Subject Helipad Sound Management Plan Peer Review
Maine Medical Center - Portland, ME
Acentech Project No. 631363

Figure 1. Mean measured DNL, summer 2018

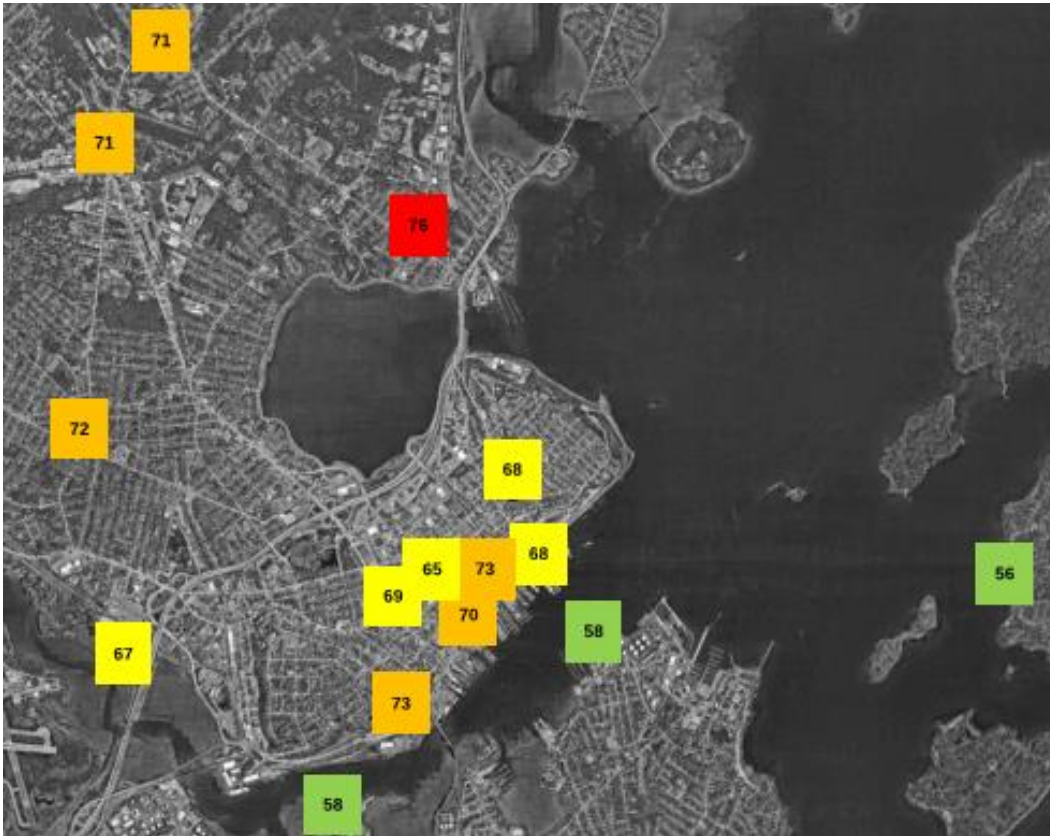
On behalf of the City of Portland, Acentech conducted a 3-month survey of existing sound levels at 13 locations in the City (as well as 2 locations in South Portland) during the summer of 2017. The mean DNL are shown in Figure 1. Our work product for this survey is part of the public domain, and we would be pleased to share it at your request.

The mean measured DNL throughout the City proper were in the range of 65 to 76 dBA, and levels at the monitoring stations nearest the existing helipad were about 70 dBA. Our spatial mapping of the measured DNL does not indicate a particularly noisy area in the vicinity of existing helipad operations or flight tracks. Rather, it suggests that long-term average noise levels in the vicinity of the project are relatively uniform and spatially homogenous.
